## Metro Inner Development Assessment Panel Agenda

**Meeting Date and Time:** Tuesday, 31 March 2026; 1.00pm  
**Meeting Number:** MIDAP/127  
**Meeting Venue:** 140 William Street, Perth

- 3.1 Lots 130 – 131 (No 321) Guildford Road, Bayswater – Proposed service station, car wash and drive thru coffee (fast food) – DAP/23/02575

*Image of previously proposed 'future adjacent commercial building'*

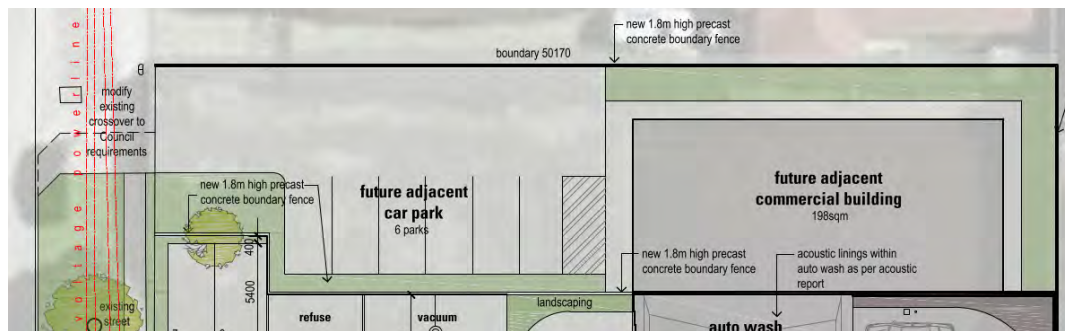
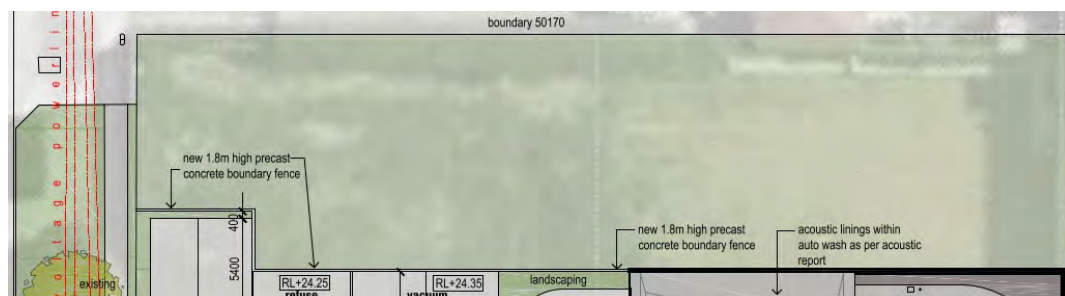
| Deferral Item No.  | Officer Comment  |
|--|--|
| 1a. Information on the proposed land use for the proposed commercial building and associated car parking (or removal). | The revised plans dated 20 November 2025 show the removal of the 'future adjacent commercial building' and associated car park. The northern portion of the site remains vacant.   |

The previous plans presented to the Metro Inner DAP on 2 October 2026 depicted a future commercial building on the northern section of the site. In response to deferral reason '1a', the revised plans dated 20 November 2025 resolved to remove this from the plans, and leave the area vacant (refer below):

*Image depicting removal of 'future adjacent commercial building' and left vacant.*
